Development Assessment Report

Council Ref: DA2022/0162

Development Application for alterations and additions to a
mixed use development approved under DA2017/0544

34 Walker Street, Rhodes

Figure 11 Extent of height non-compliance.

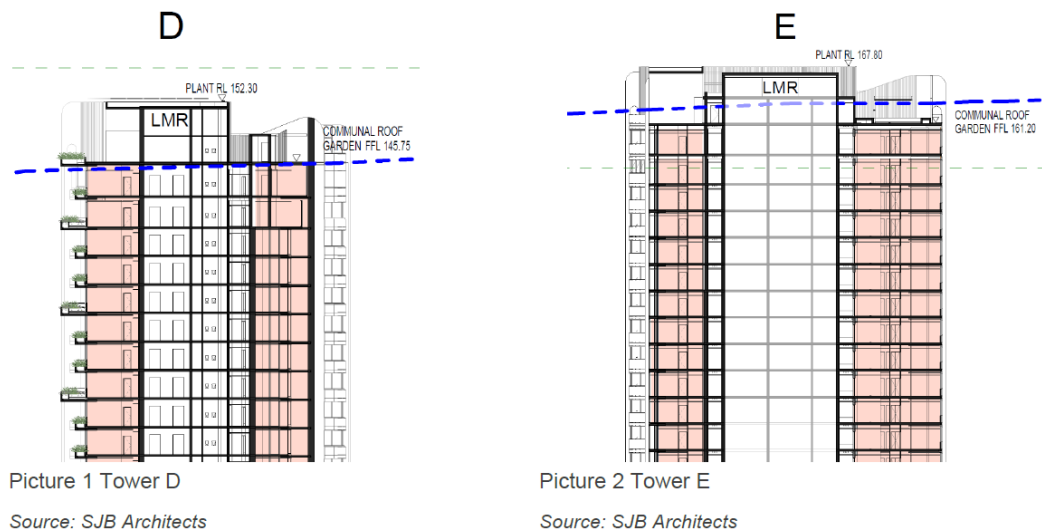
- Proposed Tower D will have a height of 143.8m which exceeds the maximum of 136.5m by 7.3m (5.3%); and
- Proposed Tower E will have a height of 156.9m which exceeds the maximum of 151.5m by 5.4m (3.6%).

The parts of the towers in excess of the height limit comprise lift machine rooms and overruns, plant and rooftop communal open space as shown in the following extracts from the architectural drawings and s4.6 variation request.

- The non-compliance arises from a technical requirement for mechanical plant and equipment;
 - The variation is minor (3.6-5.3%);
 - The LEP allows for architectural roof features above the height limit and the rooftop structures have been designed to be incorporated into the overall architectural form of the building;

- The areas above the height limit are not habitable for the purposes of residential floor space;
- The areas above the height limit provide for beneficial communal open space;
